MEMORANDUM TO: James J. Shea
Senior Reactor Engineer
Engineering Review Branch 2
Division of License Renewal

FROM: Mark A. Cunningham, Director **/RA/**
Division of Risk Assessment

SUBJECT: RESPONSE TO A NON-CONCURRENCE ON DRAFT REGULATORY
GUIDE DG-1199, "ALTERNATIVE RADIOLOGICAL SOURCE TERMS
FOR EVALUATING DESIGN BASIS ACCIDENTS AT NUCLEAR
POWER REACTORS"

Figure 1 Idealized regulatory model of airborne fission products (left) compared to realistic prediction of airborne radioactivity (right) during release phase of a DBA with core damage. Note, in actuality the source of airborne activity emanates from vessel core (right)

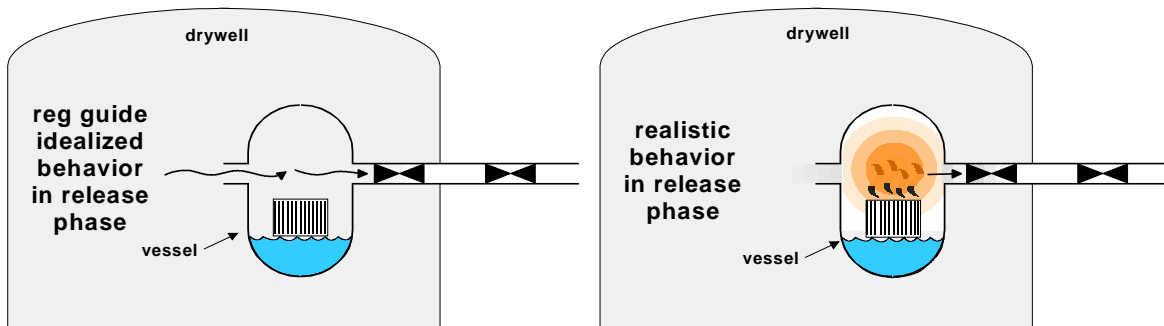
RG 1.183, Revision 0, like its Regulatory Guide 1.3 and 1.4 predecessors, assumed that the concentration of radioactivity used as the source of the MSIV leakage is approximated by the concentration of radioactivity in the containment following a postulated core melt. The radioactivity from the core melt is assumed to mix instantaneously and homogeneously throughout the free air volume of the containment building and reactor coolant system piping. This idealized view presumes that the radioactivity is released from the fuel, transported out of the vessel, and instantaneously and homogeneously distributed within the drywell volume. This equilibrated drywell atmosphere is assumed to be the source of the flow through the leaking MSIVs. In reality, the radioactivity in the vessel steam dome is not instantaneously equilibrated with the drywell or containment volume (See Figure 1).

The SNL report demonstrated that radioactivity transport is very different from the assumptions currently in RG 1.183. The current RG 1.183 methodology underestimates the MSIV leakage source term during the first two hours of the DBA. RG 1.183 assumes that the vessel and containment atmosphere are in equilibrium before reflood and that the containment atmosphere can be used as the source of the MSIV leakage. The technical validity of this assumption was explicitly evaluated in the SNL research. The SNL report documented findings from MELCOR code runs which showed that the concentration of radioactivity in the steam dome may be substantially higher than in containment until reflood occurs. After reflood, the vessel activity is swept into the containment and over time the vessel and containment atmosphere equilibrate. Therefore, consistent with the SNL research, DG-1199 proposes to use the concentration of radioactivity in the steam dome before reflood, and thereafter use the concentration of radioactivity in the containment.
